Ref: 20028.30

RE: RM20.360 Cromwell Certified Concrete Groundwater Take Effects Assessment Review

Figure 1: Groundwater standing water levels and bore locations

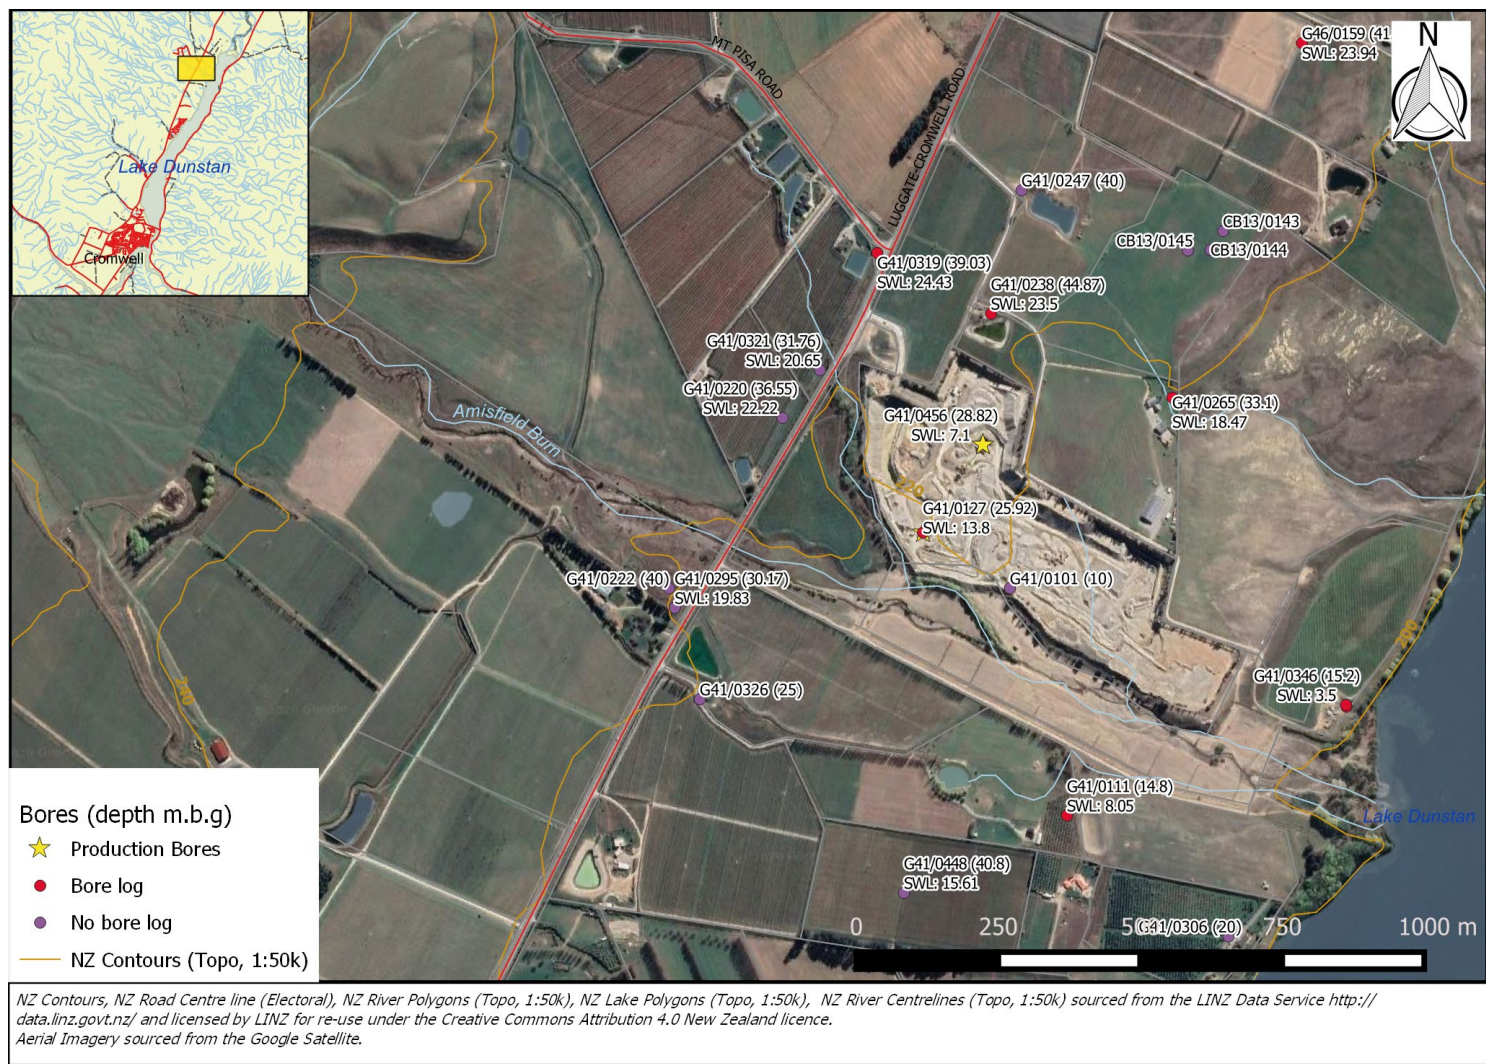
The applicant has identified the bores as being located within the Pisa Groundwater Management Zone. This zone was not identified in the current Regional Water Plan or any of its schedules, but has been identified in the draft/recommended aquifers on the ORC Water Allocation for Consultants webpage. Groundwater levels in the surrounding bores at the time of drilling are shown in Figure 1. Groundwater beneath the site flows east through the alluvial terraces towards Lake Dunstan.

Landpro (2020) state that the Amisfield Burn is approximately 20 m above the groundwater table, and therefore disconnected from groundwater. The groundwater standing levels are presented in Figure 1. The standing water levels

demonstrate that the Amisfield Burn is likely to be disconnected from groundwater at its closest point to the monitoring bores, however, as the Burn flows towards Lake Dunstan, the depth to groundwater decreases and it may become connected to groundwater. The Amisfield Burn is identified in Schedule 1A of the Regional Water Plan as providing habitat to koaro which has a threat status of 'declining'. Given that the Burn has been identified as important spawning habitat, it is important to maintain connectivity between the Burn and the Lake. The applicant should provide further assessment of the potential for the increased groundwater take to impact the flow further downstream in the Burn.
